Access Compliance Report

Public Rights-of-Way (Curb Ramps)

Intersection ID: 46918	Main Street: BLUE_ASH_LN	Cross Street: PONDEROSA_PINE_LN	Location: SW
ADA ID: 2A1D5B8ACE95	Ramp Type: Perp	Initial Pass/Fail: Fail	Overall Compliance: No
		Severity Score: 25

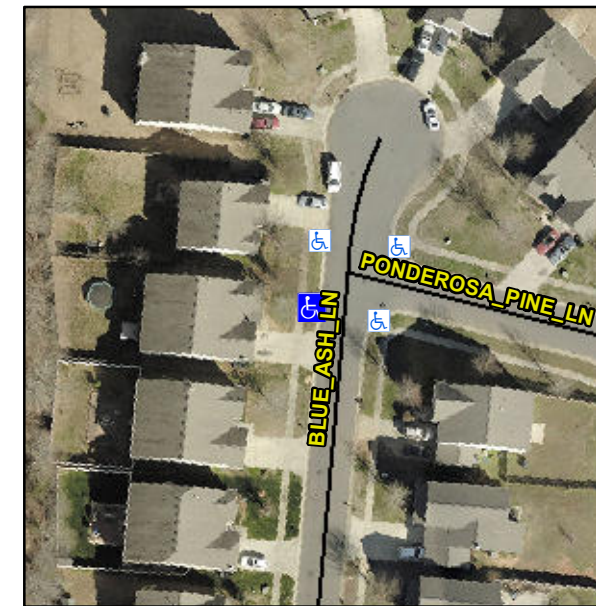
Not Found, R304.2.2, R304.5.3

Compliance	Description	Data	Compliance	Description	Data
N/A	Ramp Length (in)	84.0	No	Ramp Slope (%)	10.3
Yes	Ramp Width (in)	48.0	No	Ramp XSlope (%)	5.4
N/A	Flare Type LT	N/A	N/A	Flare Type RT	N/A
N/A	Flare Slope LT (%)	N/A	N/A	Flare Slope RT (%)	N/A
N/A	Flare Traversable LT?	N/A	N/A	Flare Traversable RT?	N/A
N/A	Landing Length (in)	N/A	N/A	DWS Provided?	N/A
N/A	Landing Width (in)	N/A	N/A	DWS Contrast?	N/A
N/A	Landing Slope (%)	N/A	N/A	DWS Length (in)	N/A
N/A	Landing X Slope (%)	N/A	N/A	DWS Full Width?	N/A
N/A	Landing Curb? (Y/N)	N/A	N/A	DWS Offset (in)	N/A
N/A	Shared Landing?	N/A			
N/A	Gutter Ponding?	N/A	N/A	Gutter Slope (%)	N/A
N/A	Gutter Lip Ht (in)	N/A	N/A	Gutter X Slope (%)	N/A
N/A	Painted X Walk1?	No	N/A	Painted X Walk2?	N/A
	X Walk 1 Direction	To E		X Walk 2 Direction	N/A
N/A	X Walk 1 Width (in)	N/A	N/A	X Walk 2 Width (in)	N/A
	X Walk 1 Slope (%)	1.3		X Walk 2 Slope (%)	N/A
	X Walk 1 X Slope (%)	6.2		X Walk 2 X Slope (%)	N/A

Remove & Replace Entire Ramp.
